**CITY OF KELOWNA
MEMORANDUM**

DATE: September 20, 2008
TO: City Manager
FROM: Planning & Development Services Department
APPLICATION NO. Z08-0030 APPLICANTS: Paul Warnock
AT: 1230 Brookside Avenue OWNER: Paul Warnock
1220 – 1222 Brookside
Avenue
PURPOSE: TO REZONE PORTIONS OF THE SUBJECT PROPERTIES FROM
THE RU6 - TWO DWELLING HOUSING ZONE TO THE RM5 -
MEDIUM DENSITY MULTIPLE HOUSING ZONE AND P3 – PARKS
AND OPEN SPACE IN ORDER TO ACCOMMODATE 41
RESIDENTIAL, ASSISTED-LIVING UNITS FOR SENIORS.
EXISTING ZONE: RU6 – TWO DWELLING HOUSING ZONE
PROPOSED ZONES: RM5 - MEDIUM DENSITY MULTIPLE HOUSING ZONE & P3 – PARKS
& OPEN SPACE ZONE
REPORT PREPARED BY: NELSON WIGHT

Subject: Proposed 41 Unit Assisted Living Building 1230 Brookside Dr. Lot 1 Plan 4386, Lot 5 Plan 5042 ODYD

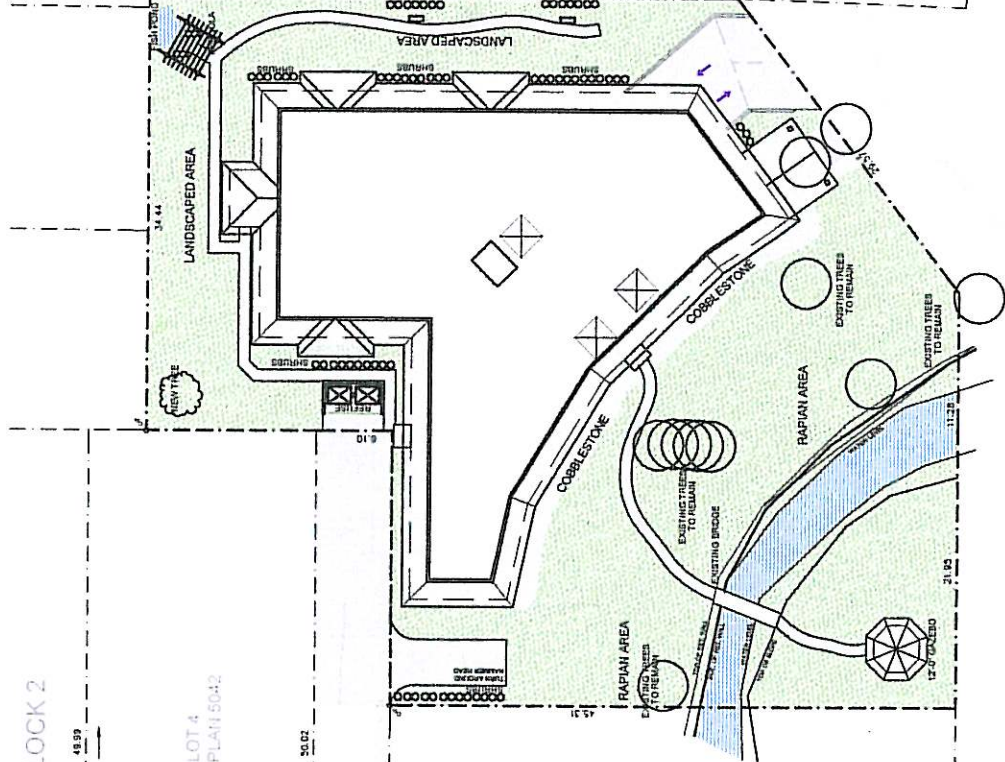
Height	13.5 m 4 storeys	16.5 m or 4 storeys
Front Yard (Brookside Ave.)	7.1 m	6.0 m
Rear Yard (north)	7.5 m ^A	9.0 m
Side Yard (east)	7.4 m ^B	4.5 m (< 2 ½ storeys) 7.5 m (> 2 ½ storeys)
Side Yard (west)	8.4 m	4.5 m (< 2 ½ storeys) 7.5 m (> 2 ½ storeys)
Projections	2.5 m ^C	maximum 0.6 m
Other Regulations		
Minimum Parking Requirements	20 spaces	1 per principal dwelling, plus 1 stall per three bed spaces and 1 per resident staff member Total required: (1 resident staff x 1 + (41 bed spaces / 3 = 14) = 15 spaces
Small Car Parking Spaces	5 small car spaces	Maximum 40% small car 15 x 40% = maximum 6
Continuous Building Frontage	(meets requirements)	No continuous building frontage shall exceed 40.0 m for a 3 or 4 storey building
Bicycle Parking	Inside: 64 Outside: 7	Residential Inside: 0.5/unit = 34 Outside: 0.1/unit = 7
Private Open Space	(meets requirements)	A minimum area of 7.5 m ² of private open space shall be provided congregate housing bedroom 7.5 m ² x 41 = 308 m ²

^A The applicant will need to apply for a development variance permit to address this conflict or alter the building to comply with the regulation.

^B The applicant will need to apply for a development variance permit to address this conflict or alter the building to comply with the regulation.

^C The applicant will need to apply for a development variance permit to address this conflict or alter the building to comply with the regulation.
